Final Drainage Report

Canyon Creek Ranch

April, 2022

Add PCD File No.
MS2213

EXHIBIT 2: FEMA FIRM MAP

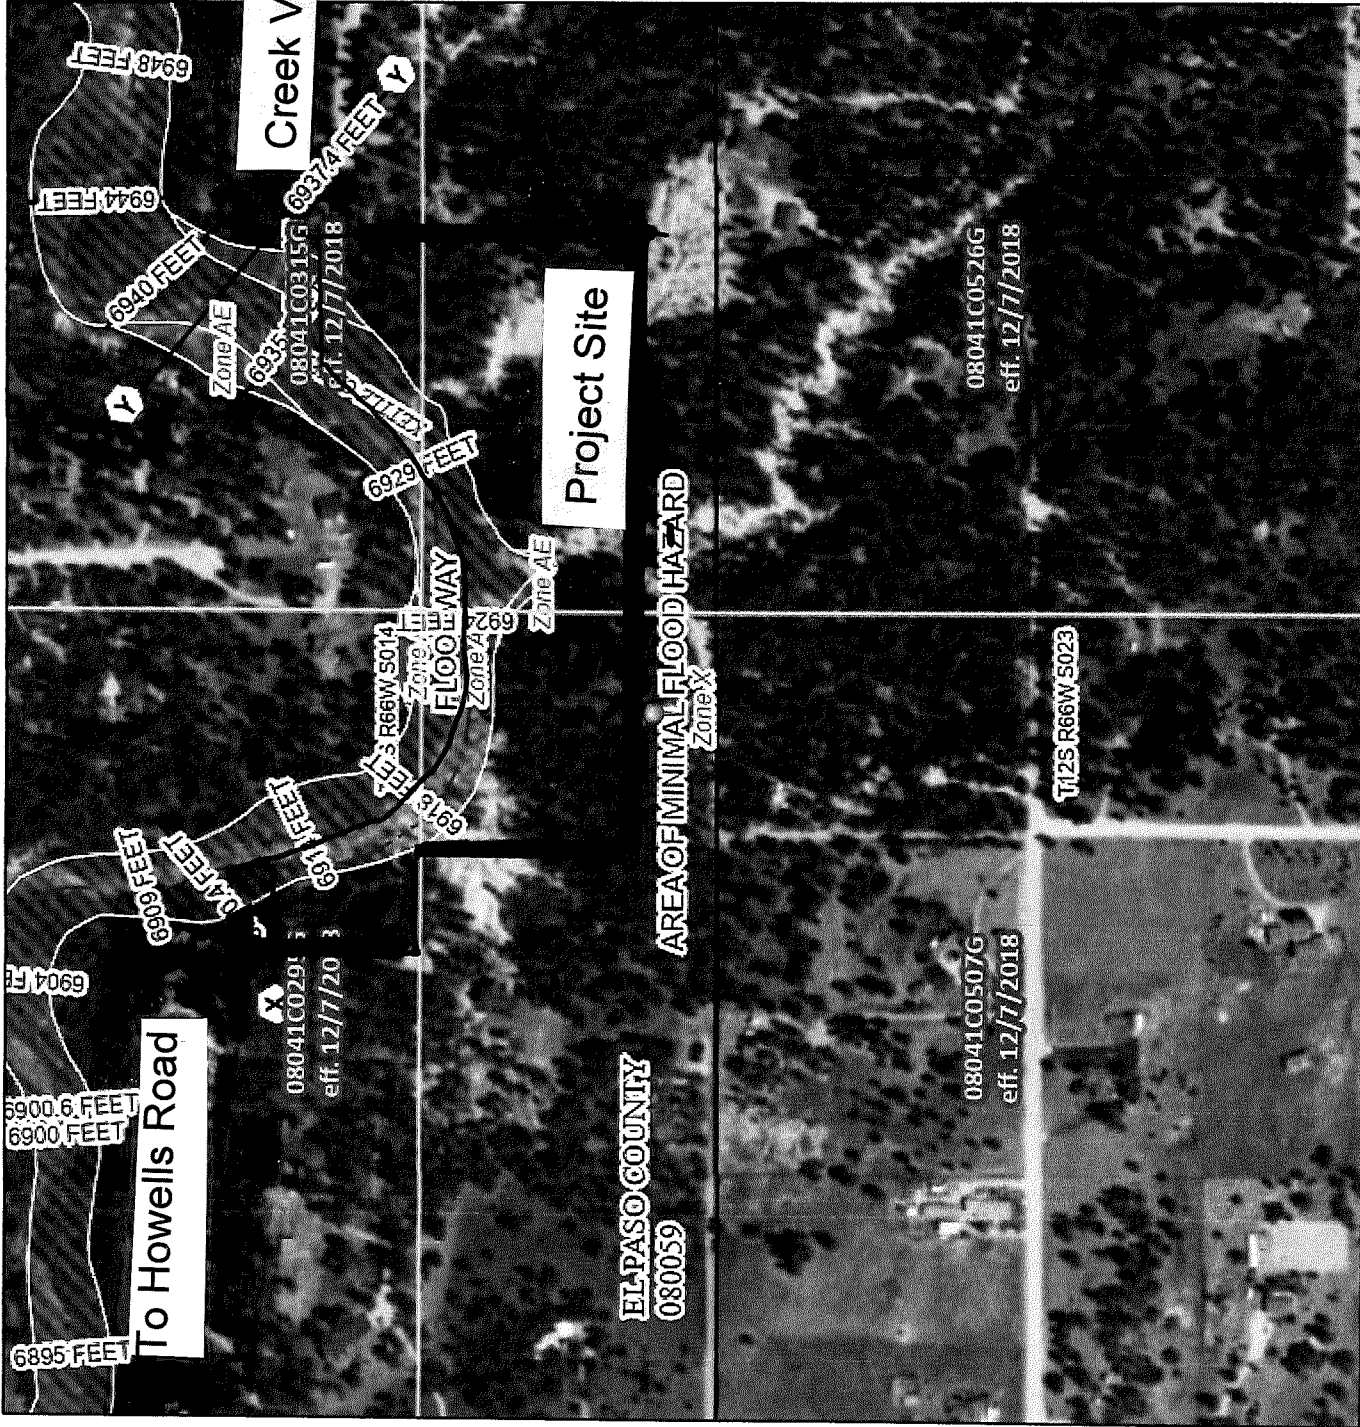
Revise to 08041C0507G and 08041C0526G.

Identify the zone of the 100yr floodplain going through the site

Rouine #1
 48" CMP

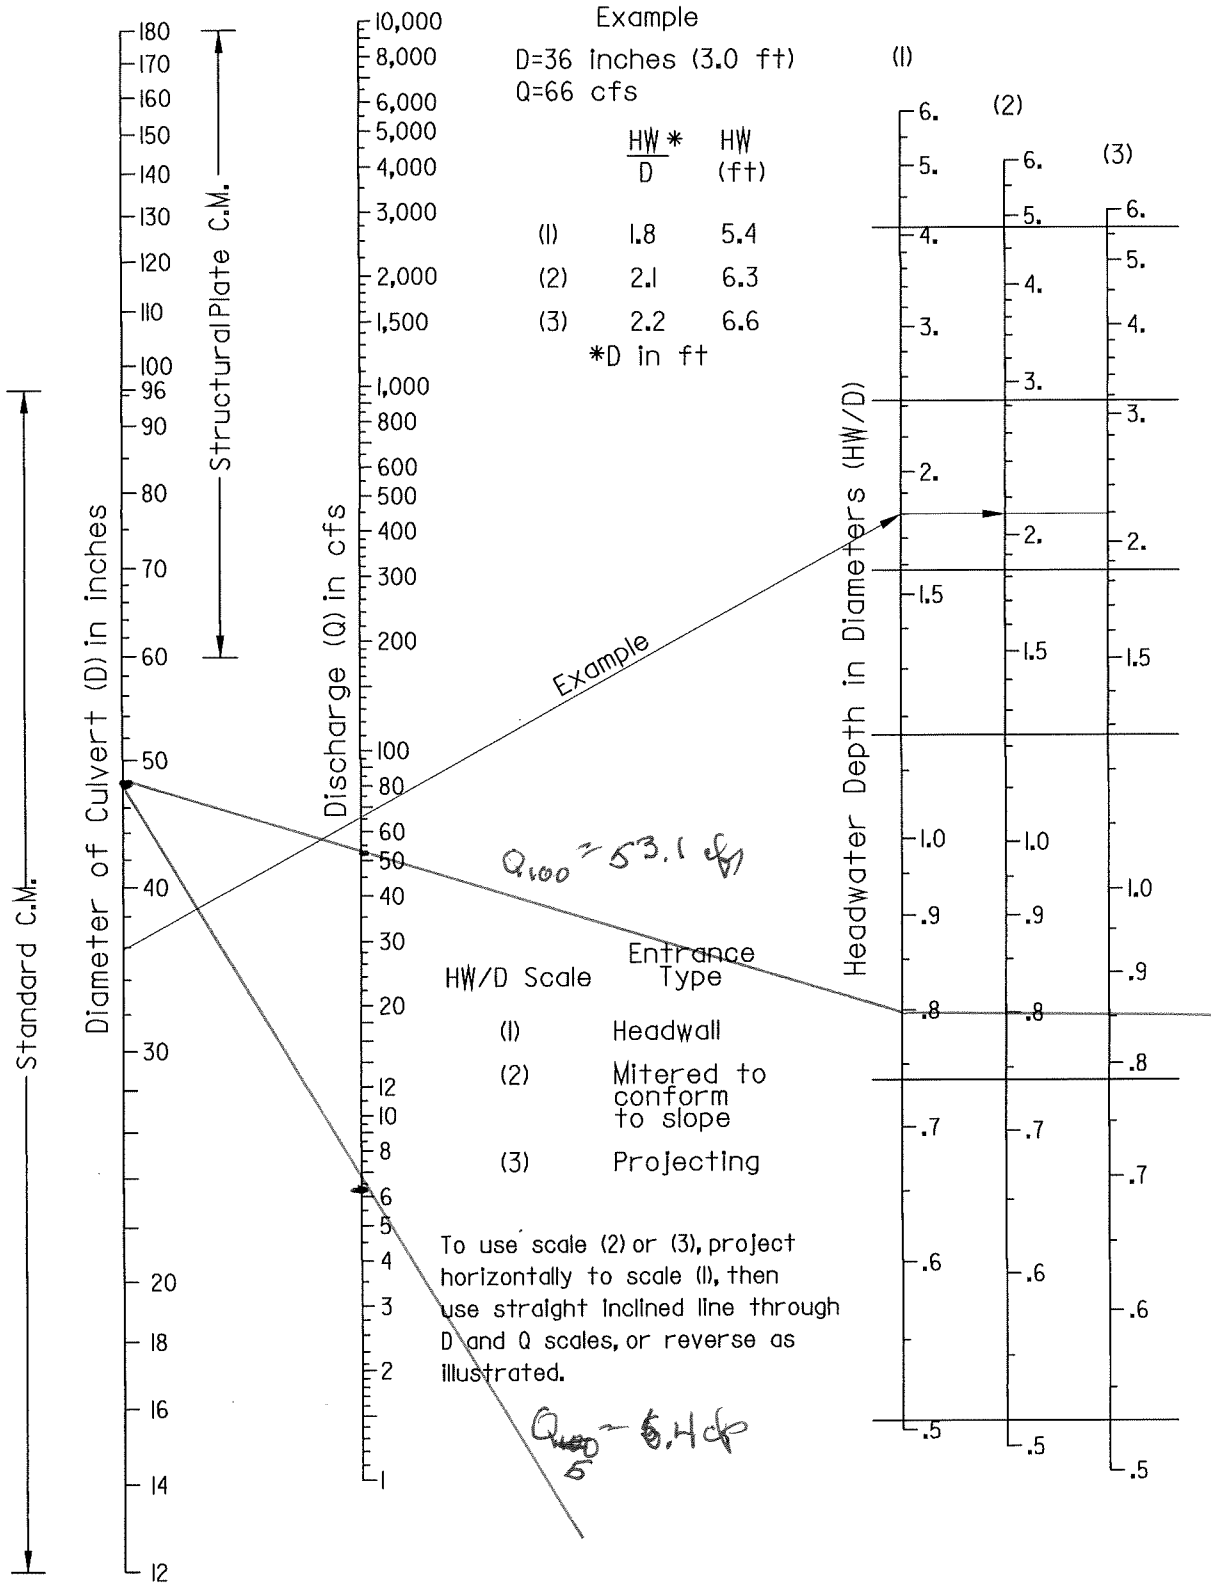
Per EPC DCM VOL. 1 table 6-5, HW/D needs to be 1.5 or less. Revise to meet criteria.

Ravine Z

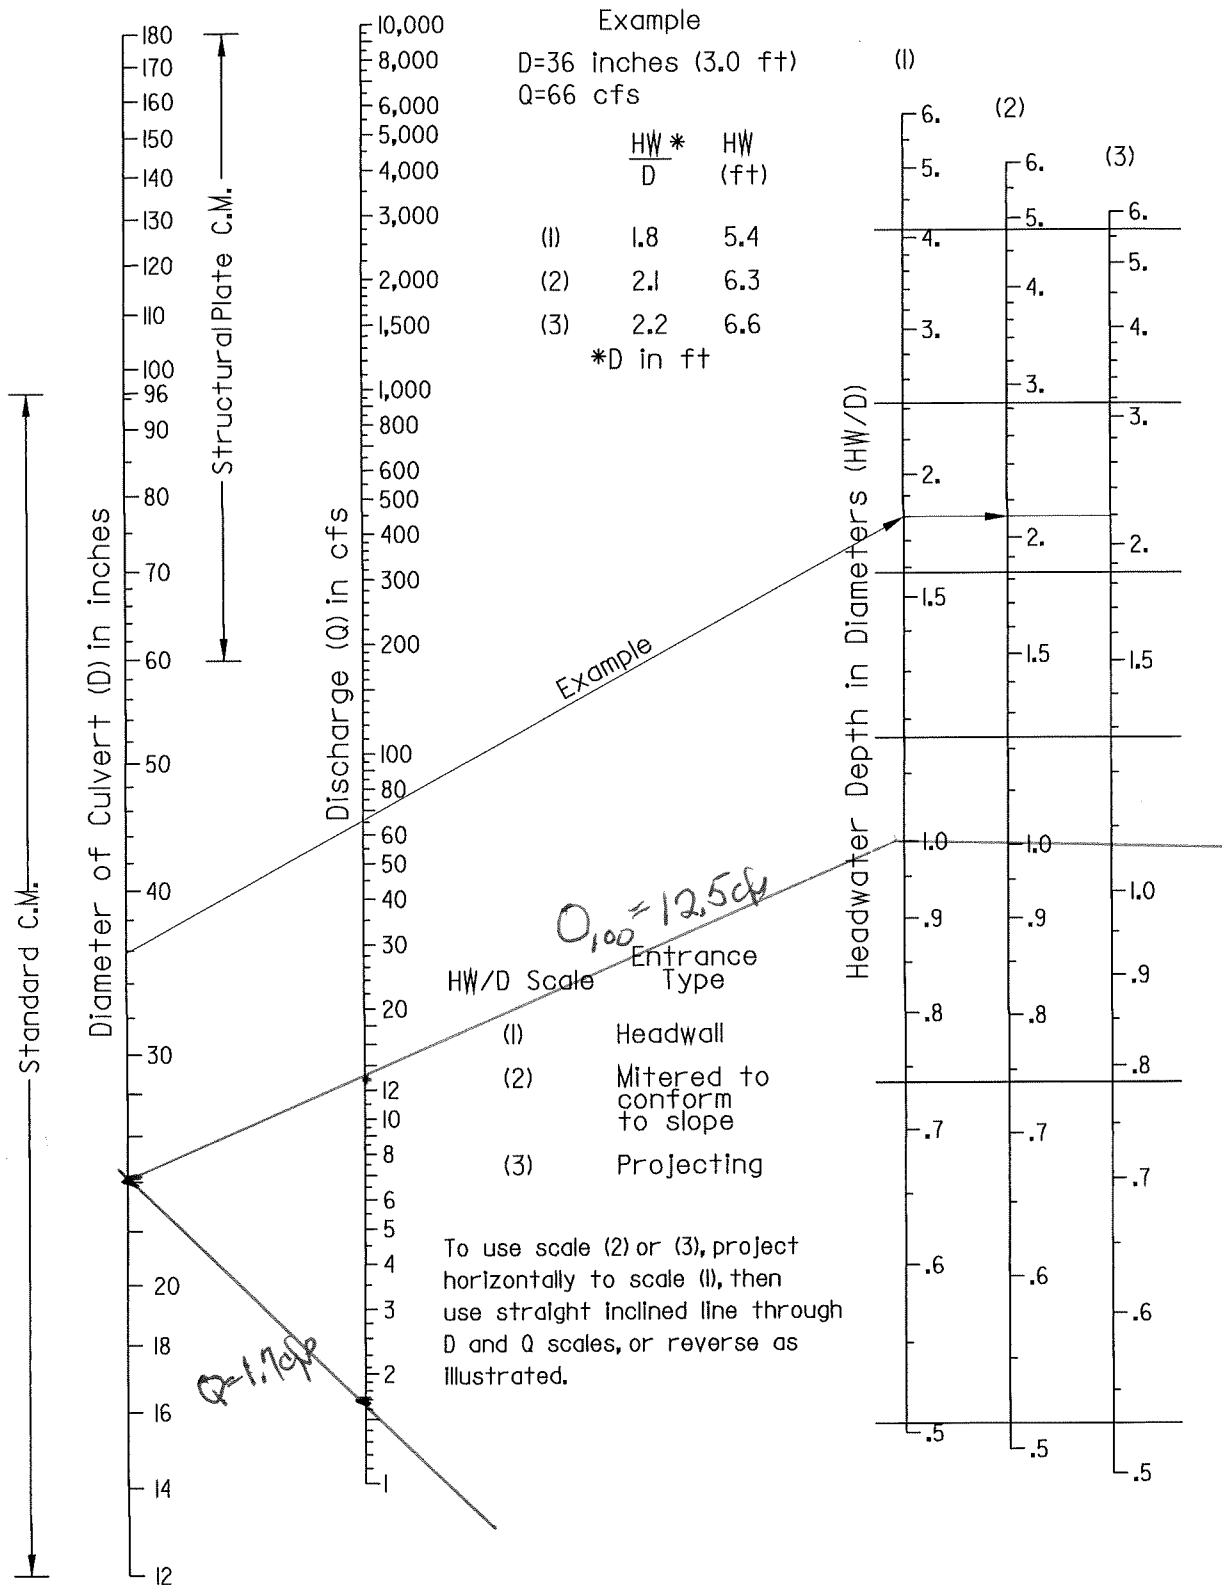
Per EPC DCM VOL. 1 table 6-5, HW/D needs to be 1.5 or less. Revise to meet criteria.

CANYON CREEK RANCH
DRAINAGE PLAN FOR EXISTING CONDITIONS
Project No.: 21002
Sheet: 2 of 3

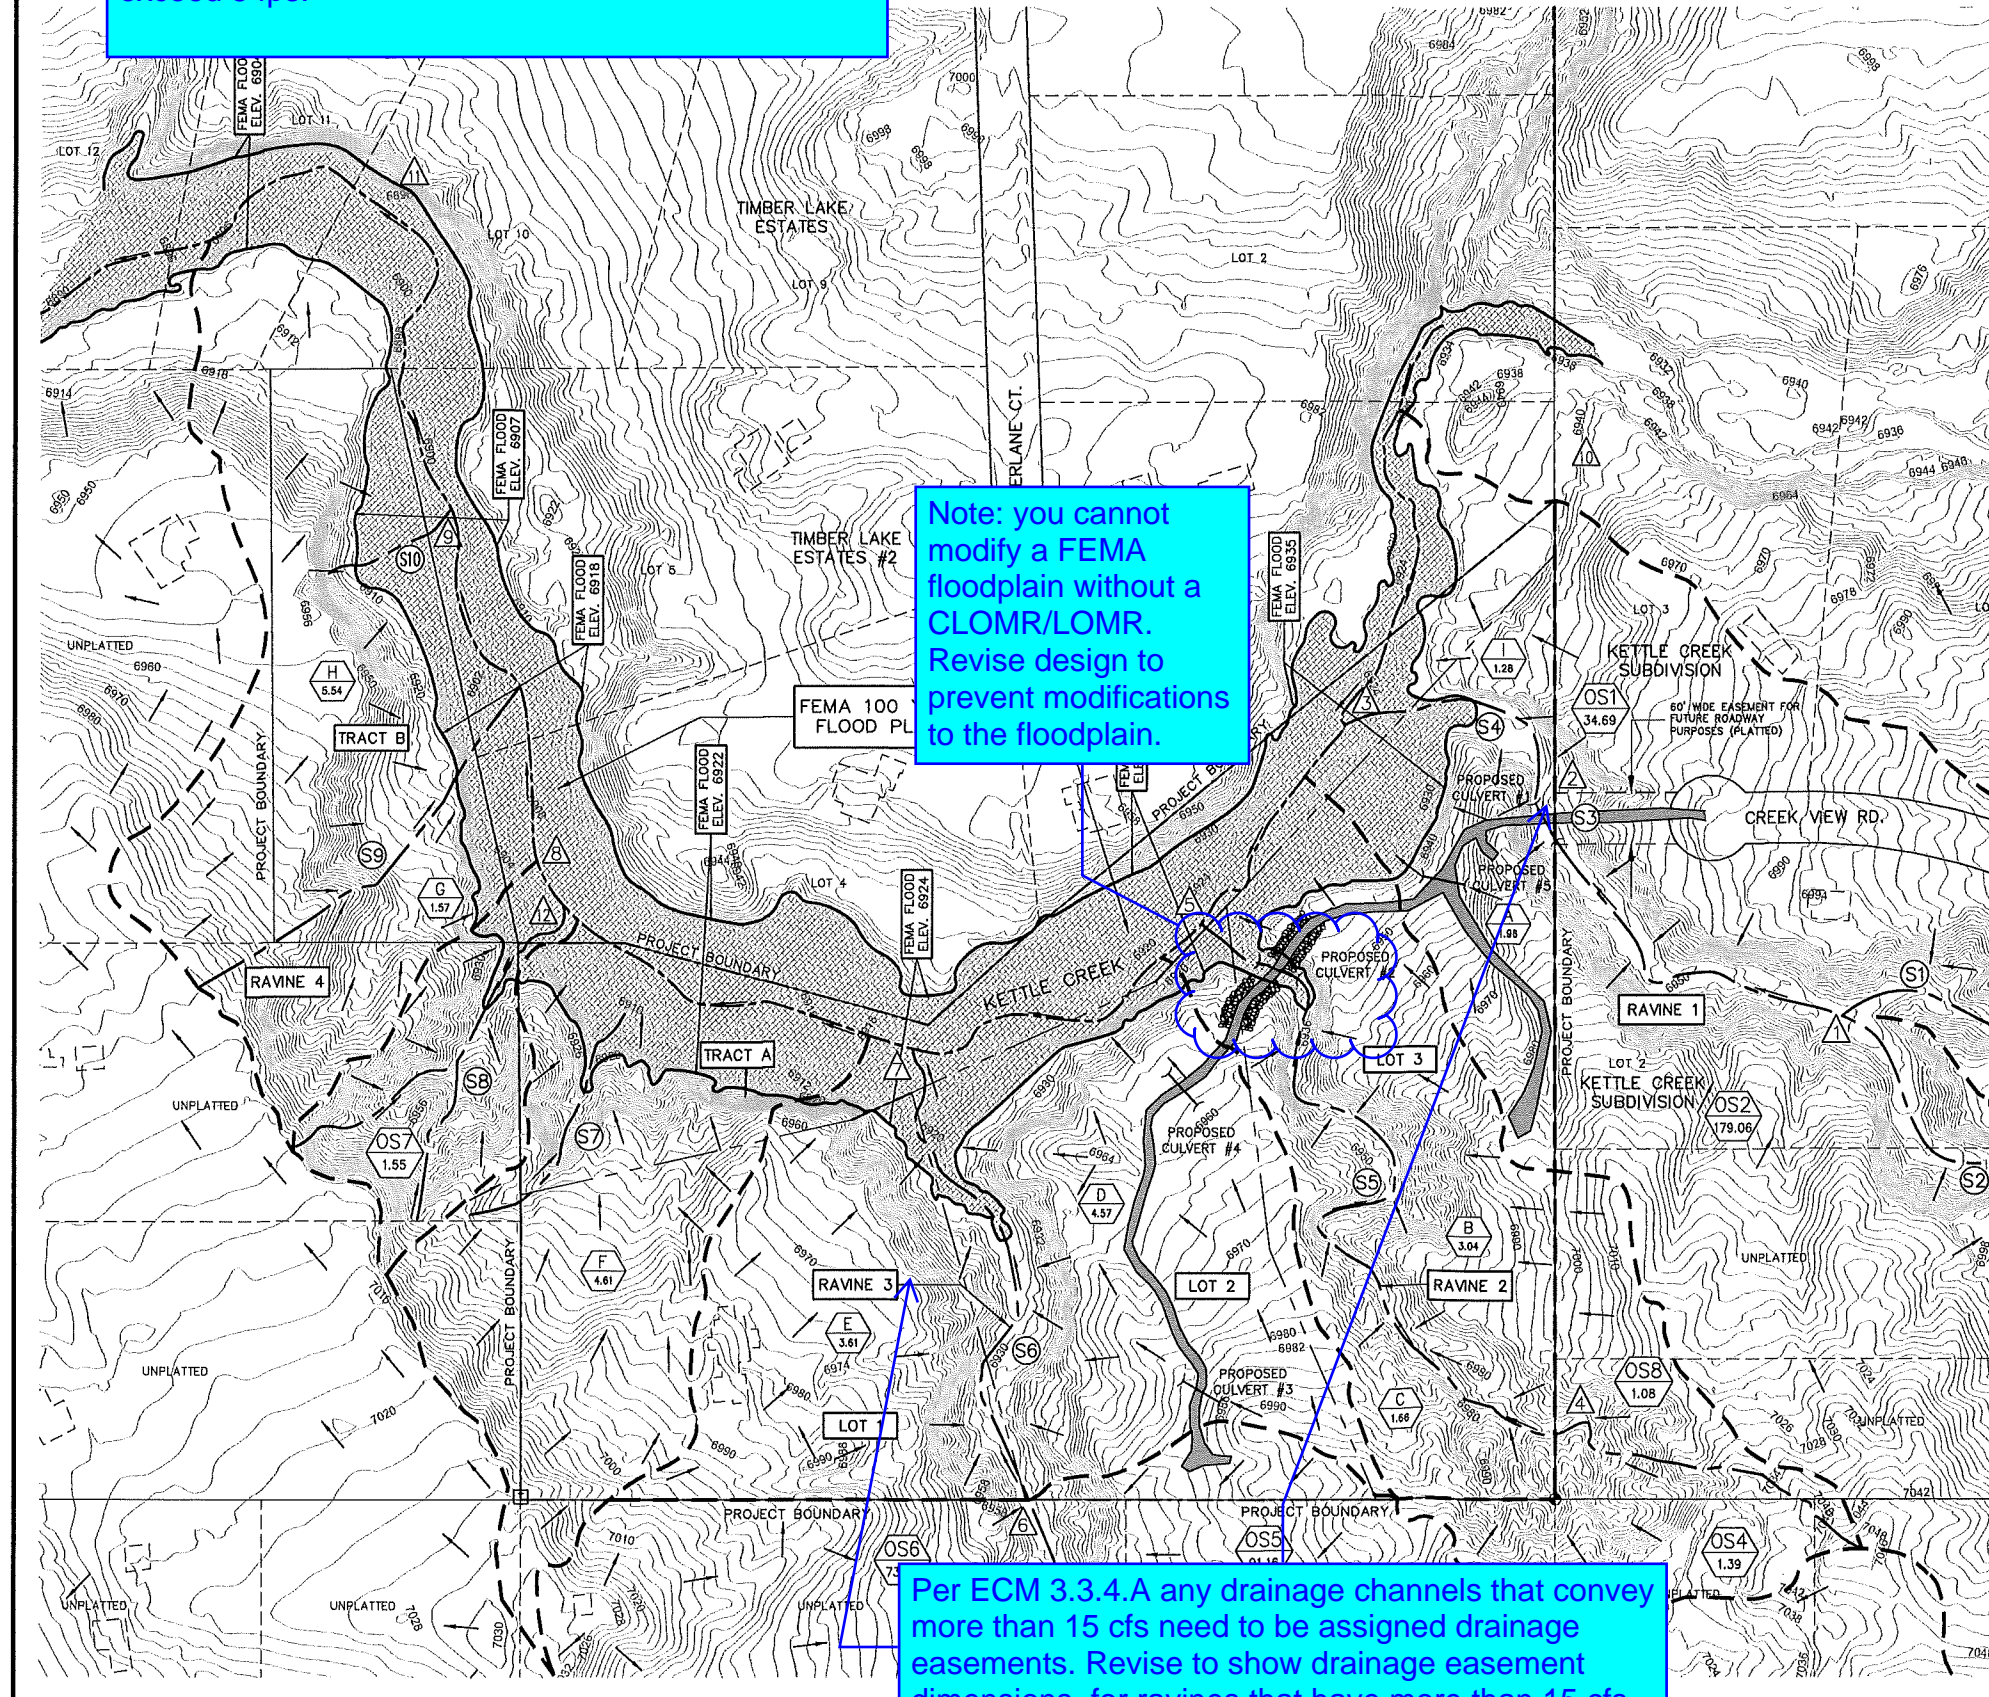
Note: you cannot modify a FEMA floodplain without a CLOMR/LOMR. Revise design to prevent modifications to the floodplain.

Per ECM 3.3.4.A any drainage channels that convey more than 15 cfs need to be assigned drainage easements. Revise to show drainage easement dimensions. for ravines # that have more than 15 cfs.
